### 5.1. Bulk and Scale and Visual Impacts

## 5.2 Heritage Values:

Figure 7: Existing view from Driver Ave over Members Stand

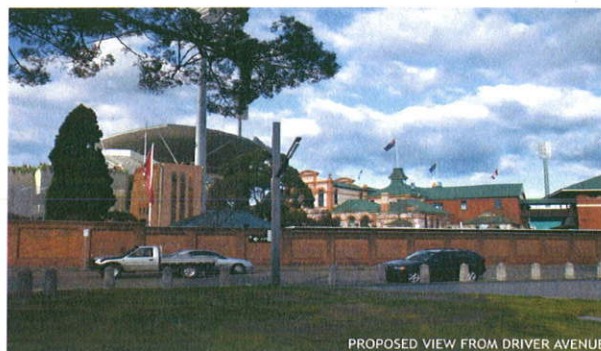
The modification involves a substantial increase in floor space over four levels of the Stand to the north towards the Sydney Football Stadium (SFS). The increased building footprint will reduce the separation between the SCG and the SFS to approximately 30 metres, compared with 50 metres under the original Noble/Bradman Stand approval. The Proponent has provided a series of photomontages depicting the building separation and relationship between the SCG and SFS and visual impacts from FOX Studios and Driver Avenue. Refer to Figures 7 to 10 below.

The buildings rear bulk is contained solely on the Trust's land and therefore would only result in amenity impacts for occupants of the Trust land. The modification additions adjoin a portion of the boundary with the FOX Studio complex and thus will present a six storey appearance directly on that boundary for a distance of approximately 30 metres. No objection to this design change has been raised by the lessee (FOX Studios) or landowner (Centennial Park and Moore Park Trust) although general support has been shown for the removal of the encroachment over the adjoining land.

On this basis, the bulk and scale of the northern additions to the approved stand and its relationship with the SFS is considered to be acceptable.

Based upon the above considerations, and after assessment of the building form photomontages, it is considered that the bulk, scale and visual impacts of the proposed additions are reasonable in the context of this development and site.
